Addendum

Addendum Number:	ADD-03
Addendum Date:	02.09.21
Project Number:	20-035
Project Name:	Public Works Vehicle Storage Addition
Owner:	City of St. Charles, MO

S1.1
SHEET

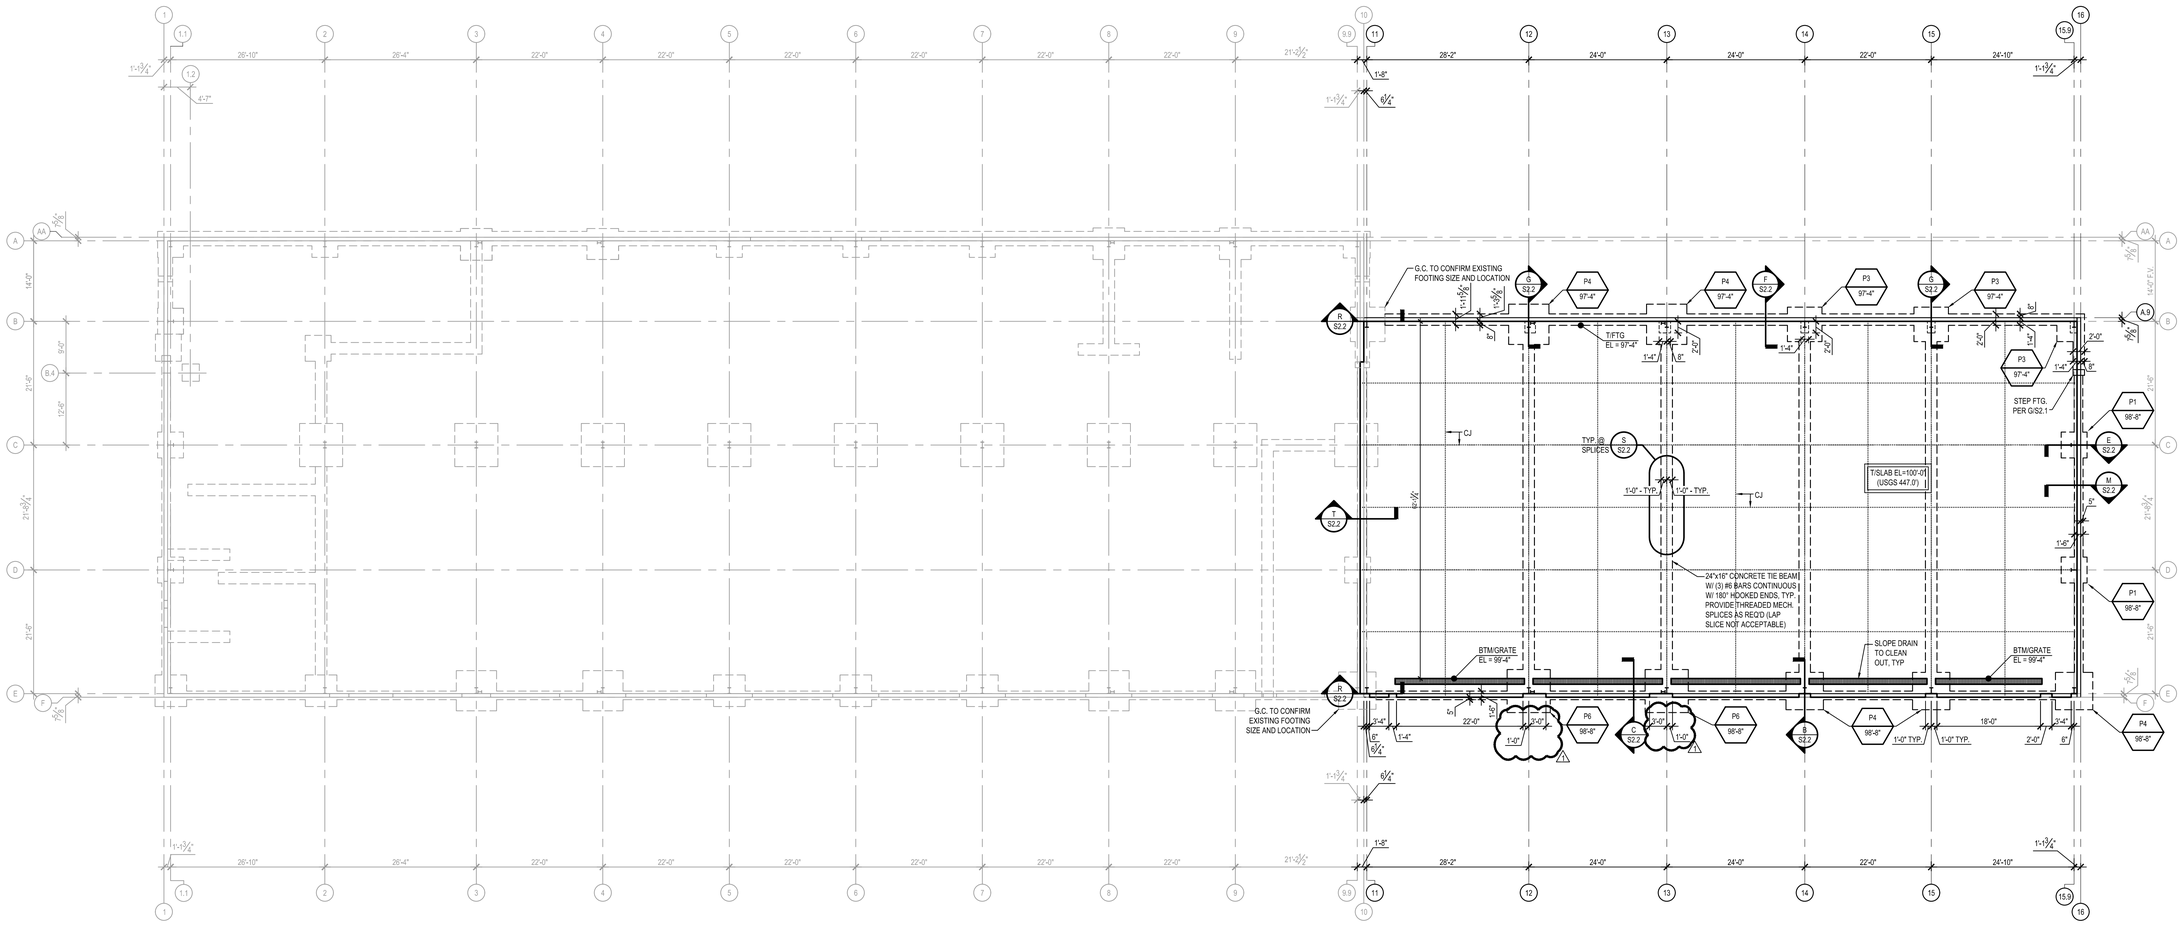
1. S1.1 Vehicle Storage Foundation Plan
    a. Changed the drawing mark sheet reference to coordinate with the sheet
    b. Changed slab line dimensions to allow for different size door between grid lines 12 and 13
    c. GENERAL PLAN NOTES Omitted note for line item 4
    d. GENERAL PLAN NOTES Omitted note for line item 6

S2.2
SHEET

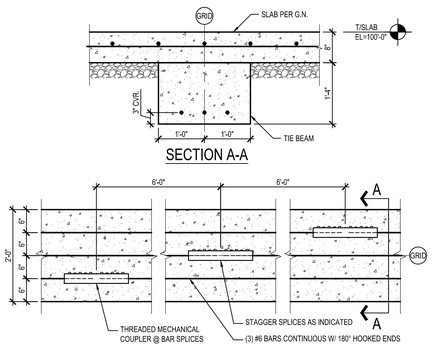
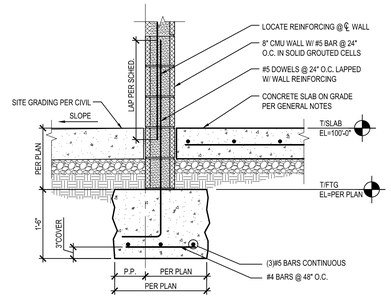
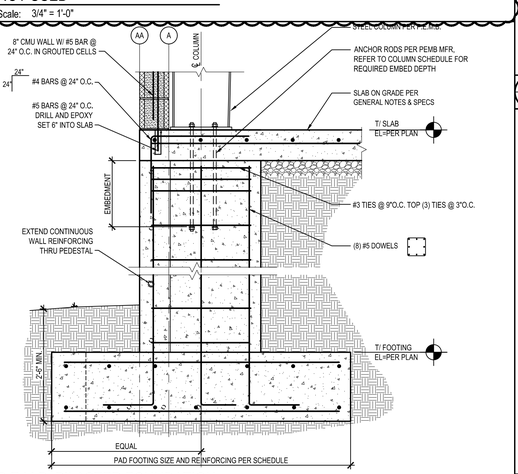
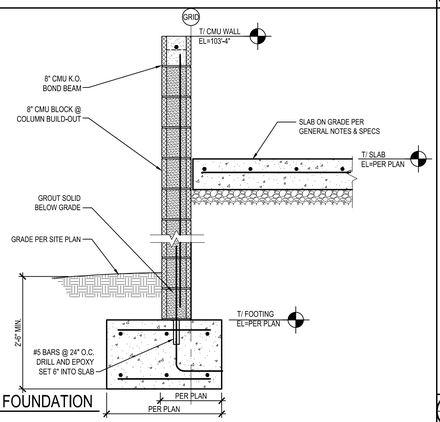
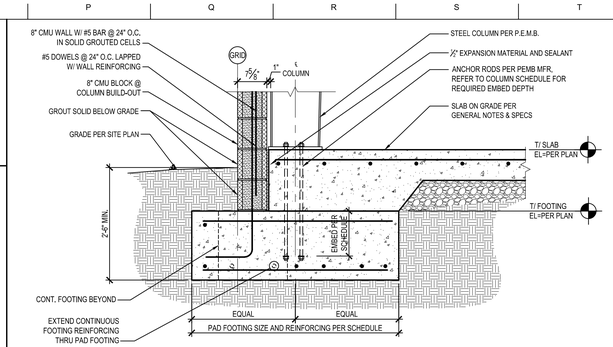
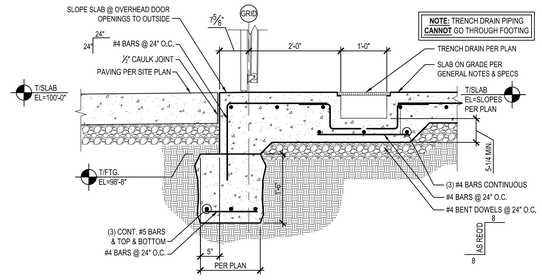
2. S2.2 Vehicle Storage Foundation Details
    a. Removed detail due to condition not being in current scope

A S3.2 FLEET SERVICES - ROOF FRAMING PLAN

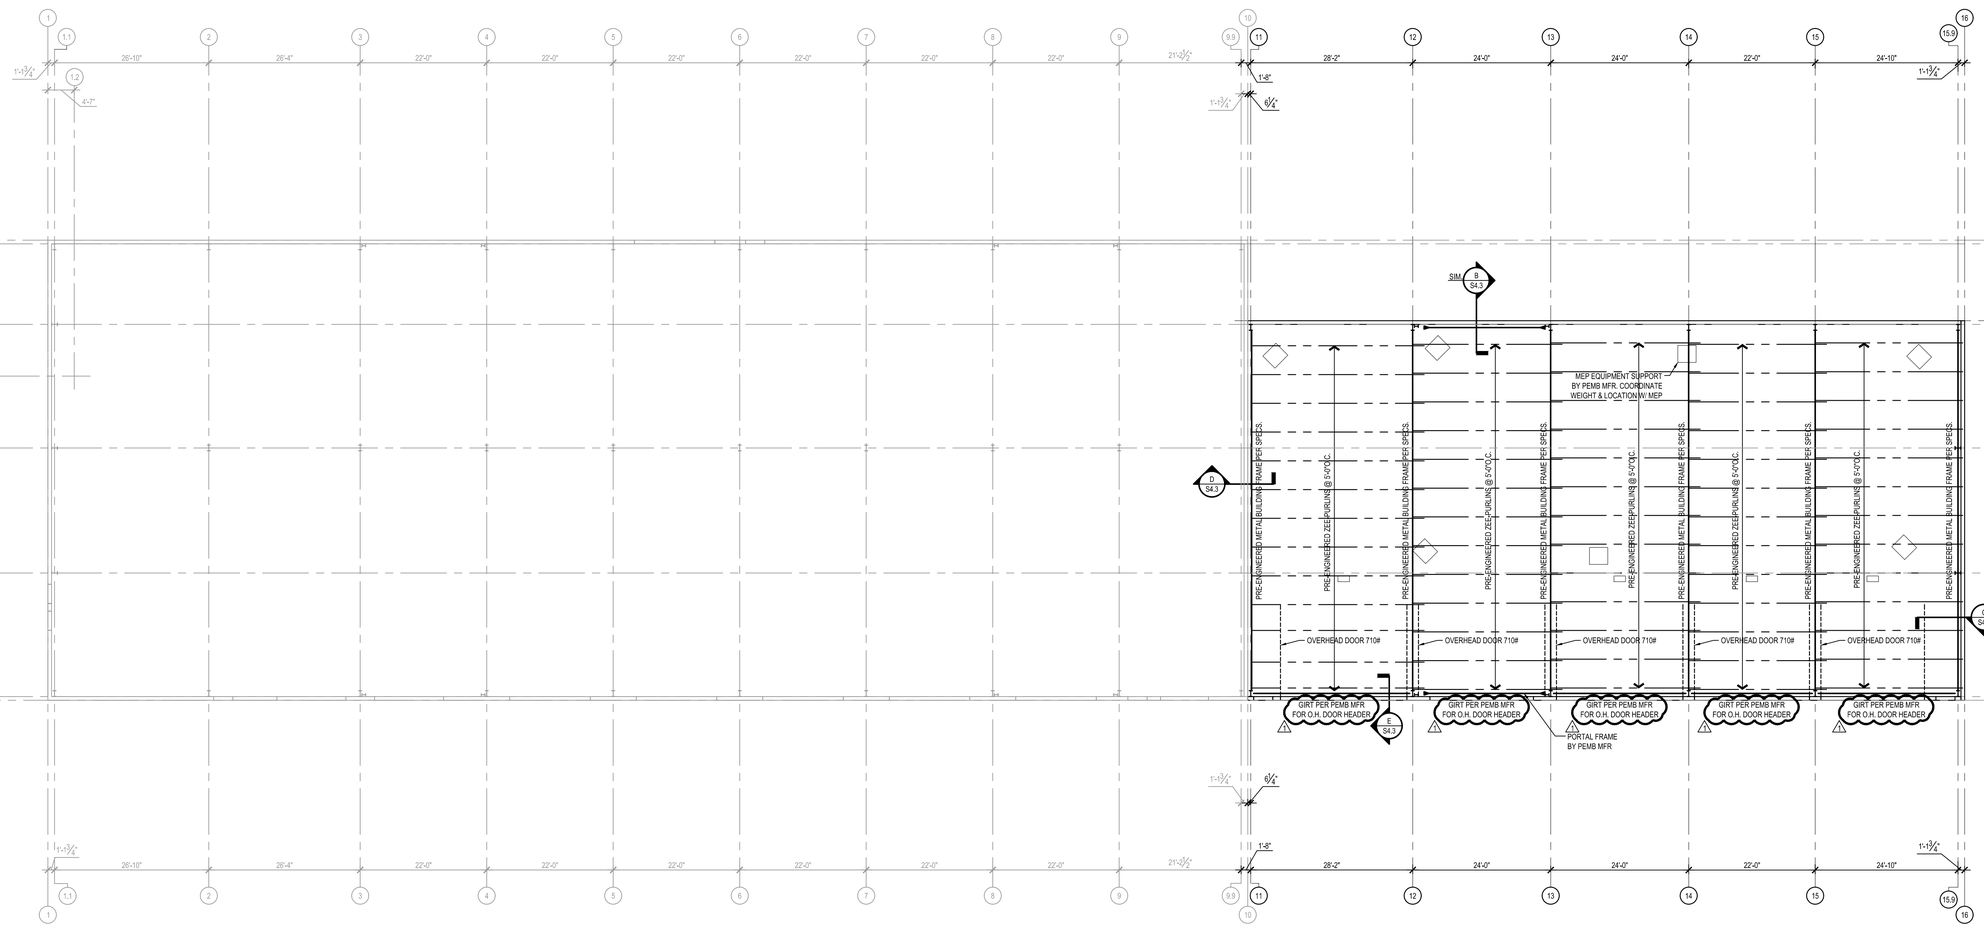
3. S3.2 Vehicle Storage Roof Framing Plan
    a. Removed HSS headers called out along grid line E and replaced with girt per PEMB manufacturer note

S4.3
SHEET

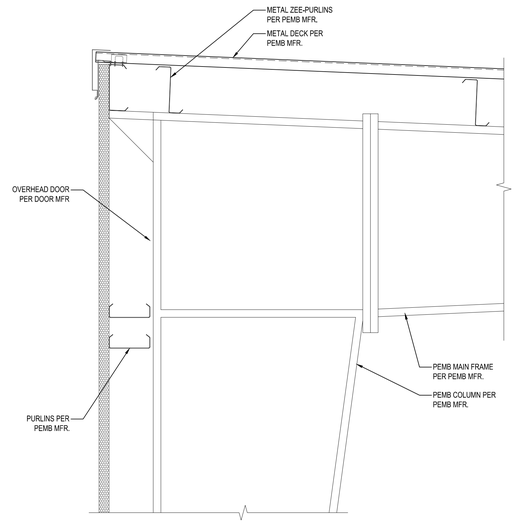
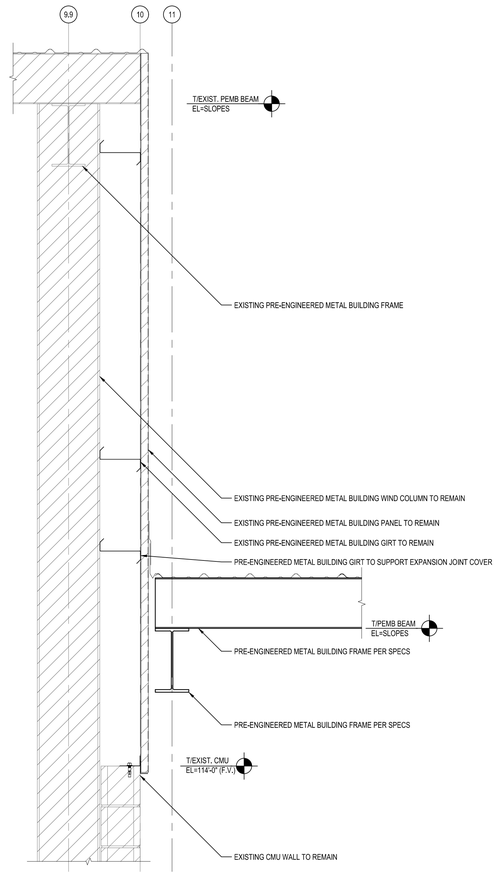
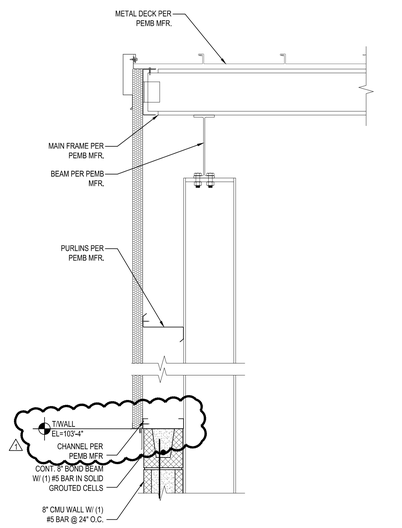
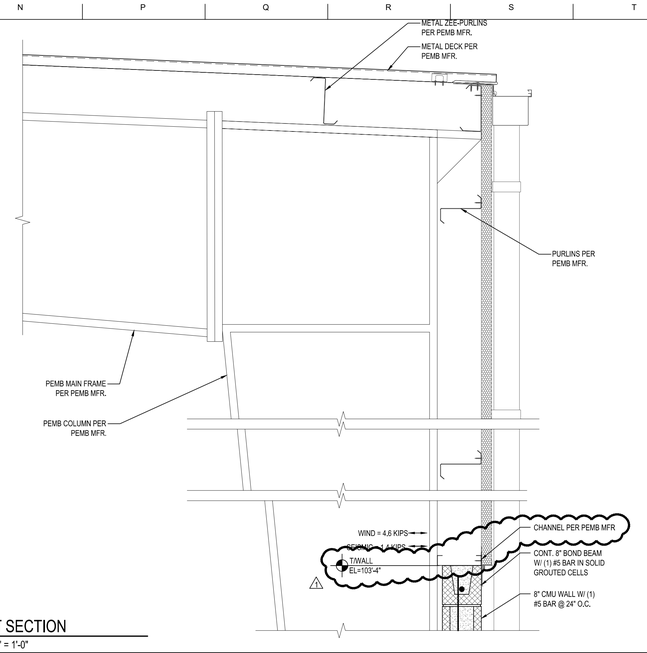
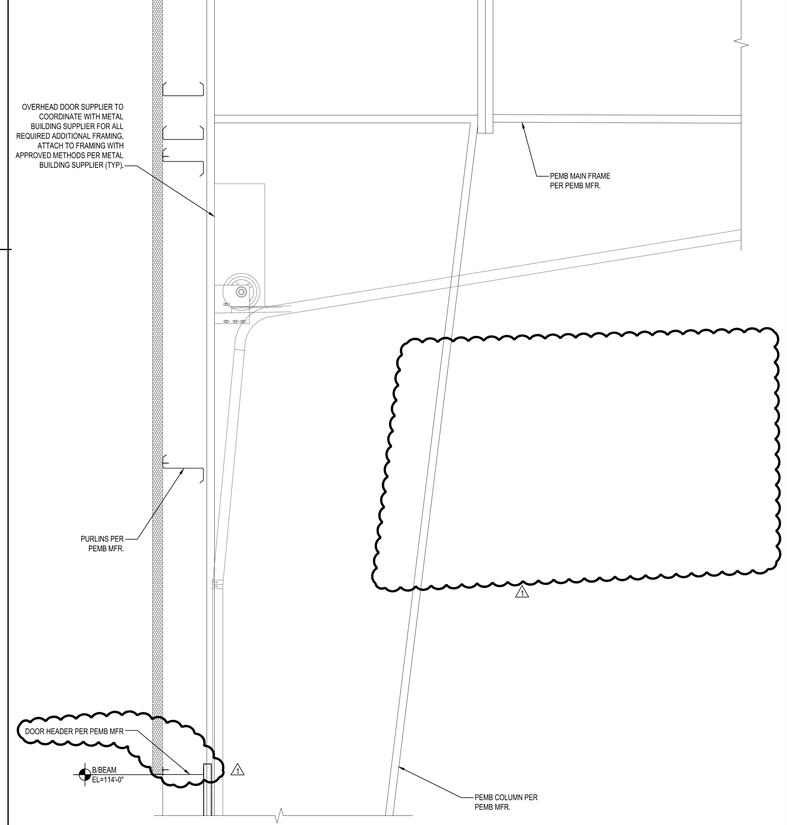
4. S4.3 Vehicle Storage Framing Details
    a. Changed out HSS beam for PEMB girt both graphically and in notation
    b. Removed overhead crane system that was not part of current scope
    c. Removed prior HSS on top of CMU wall and replaced it with PEMB channel
    d. Changed T/WALL elevation
    e. Removed prior HSS on top of CMU wall and replaced it with PEMB channel
    f. Changed T/WALL elevation

029	Closed	2/3/2021	EMAIL		Sheet S4.3, detail A shows a crane assembly attached to the building. Can you confirm that this is not part of this project?	See response to pre-bid RFI-019.	2/3/2021	Joe Sweitzer, Navigate Building Solutions	Adden 1
030	Closed	2/3/2021	EMAIL		Sheet S4.3, details B and C show a hollow structural section above the masonry with headed anchor studs. Are the anchor studs welded to the HSS? Sheet A6.3, Detail 1N seems to show a mechanical connection.	The connection above the masonry to PEMB panels in all conditions are going to be now called out by PEMB supplier. The HSS tube would be considered as overengineered for a cantilevered wall of this height	2/5/2021	Bryon Oster, H Design Group	Adden 2

#	Status	Received date	Received how	Received from	Question	Response	Response date	Responder	Issued via Addendum
031	Closed	2/3/2021	EMAIL	[redacted]	Sheet S4.3, detail B shows a hollow structural section above the masonry with headed anchor studs. There is some kind of plate shown above the hollow structural section that is welded to the HSS and the column? The plate is labeled as another HSS 8x4x3/8"w/1/2"diam x 4" HAS. a.What is the plate? b.Does this plate get welded to each column? Detail C does not show this plate above the HSS.	The connection above the masonry to PEMB panels in all conditions are going to be now called out by PEMB supplier. The HSS tube would be considered as overengineered for a cantilevered wall of this height	2/5/2021	Bryon Oster, H Design Group	Adden 2
032	Closed	2/3/2021	EMAIL		Will all of the material and special testing be paid for by the owner?	See response to pre-bid RFI-017.	2/3/2021	Joe Sweitzer, Navigate Building Solutions	Adden 1

SHEET
A1.2

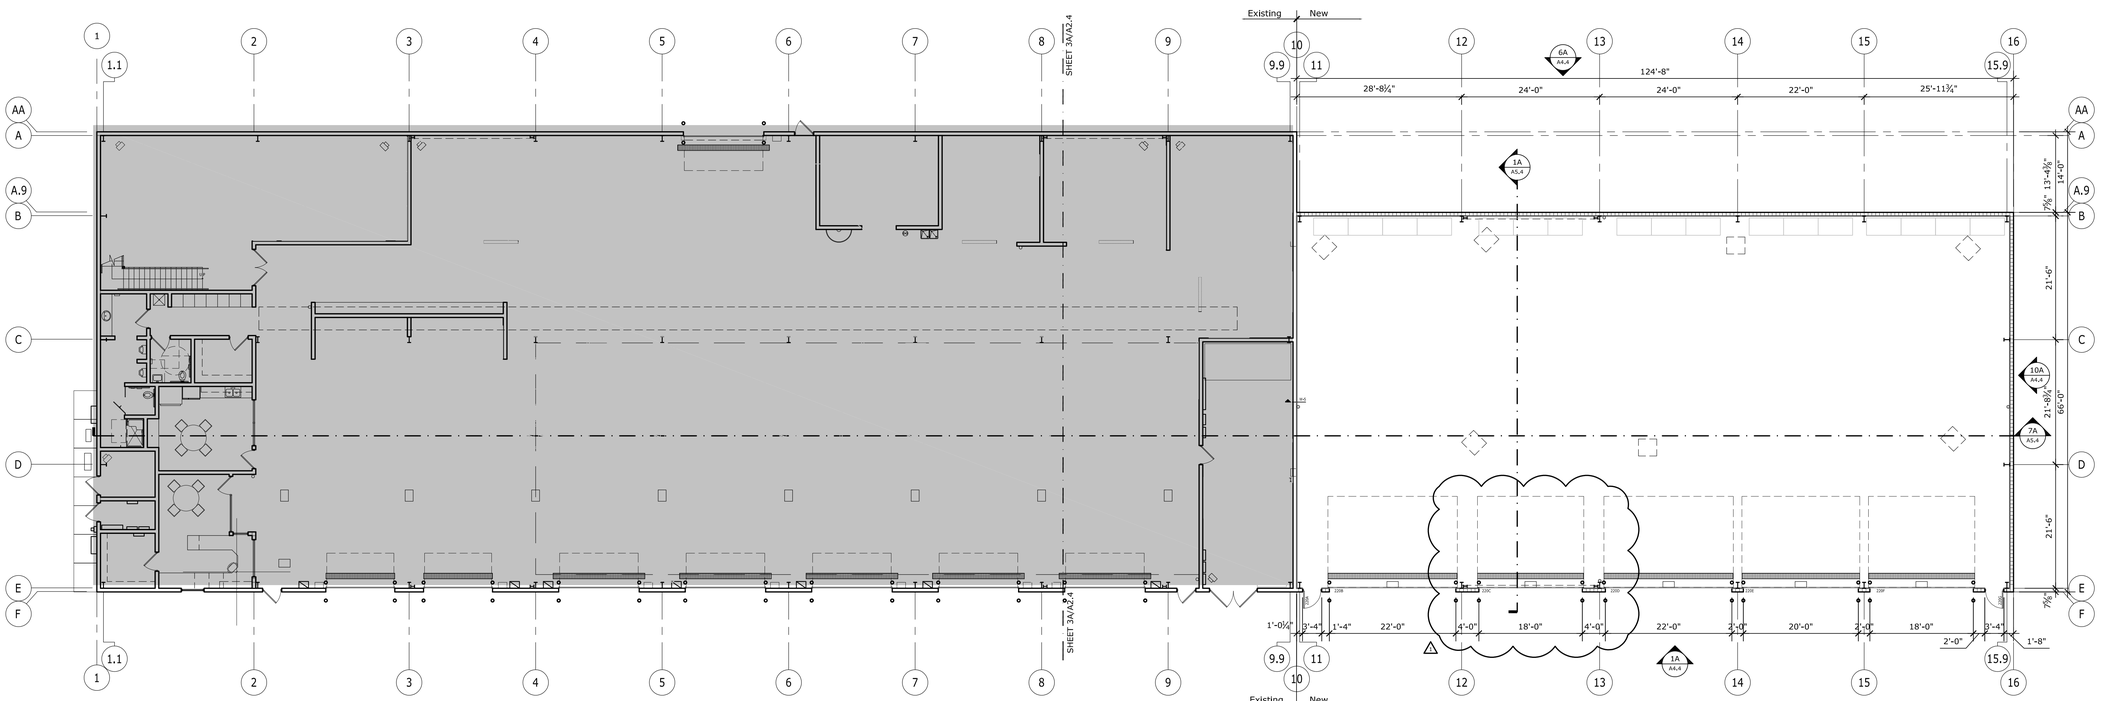
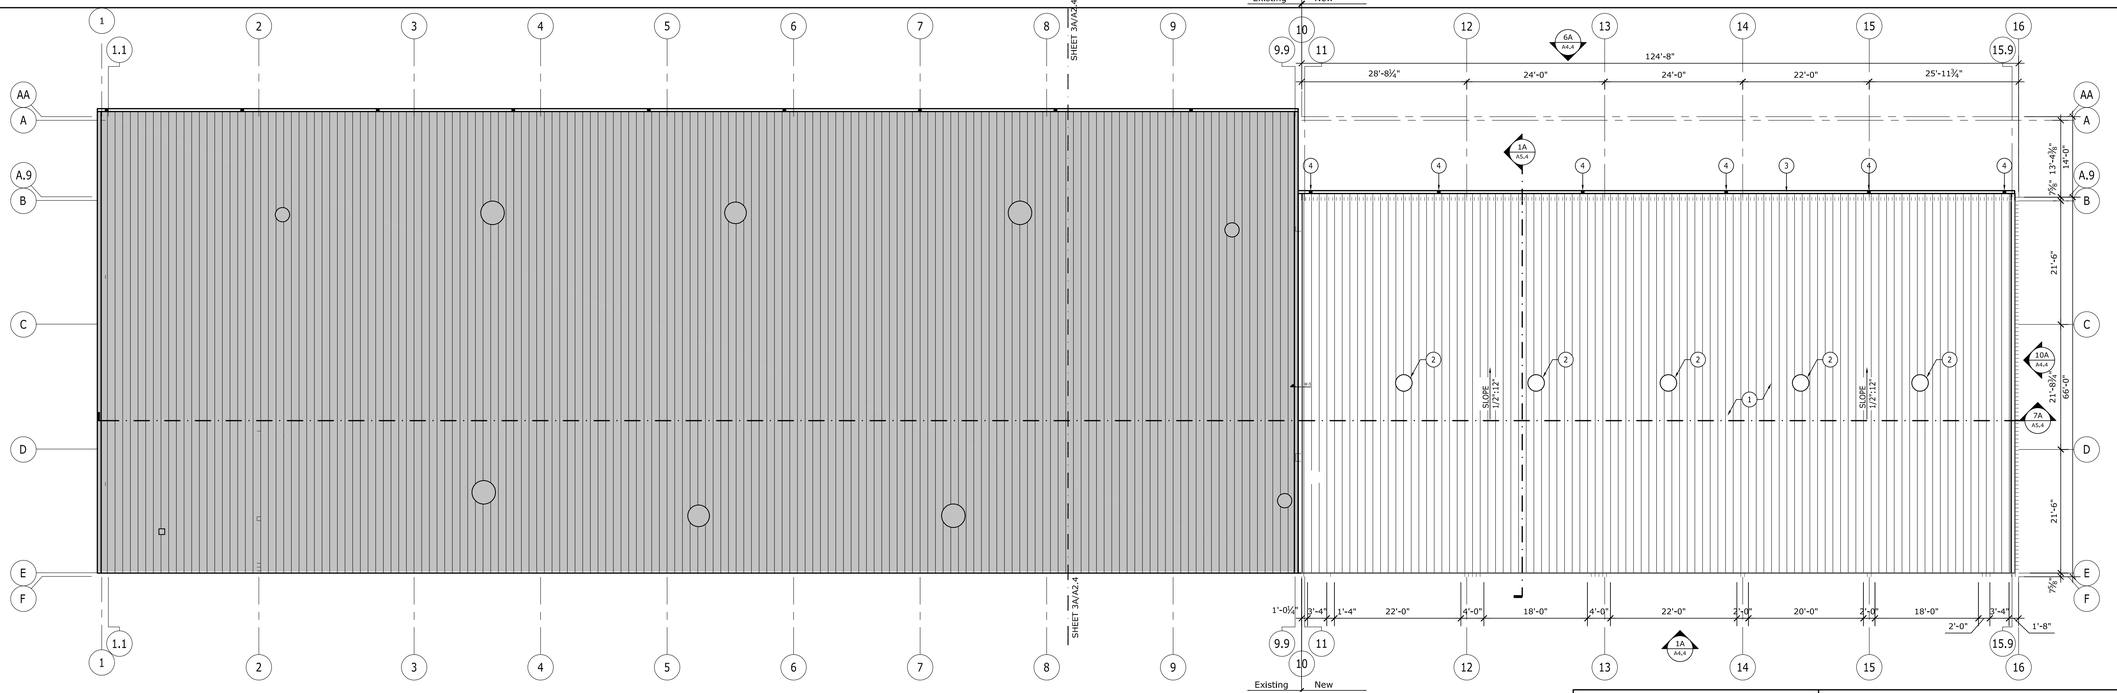
5. A1.2 Vehicle Storage Floor & Roof Plan
    a. Revised width of overhead door 220C
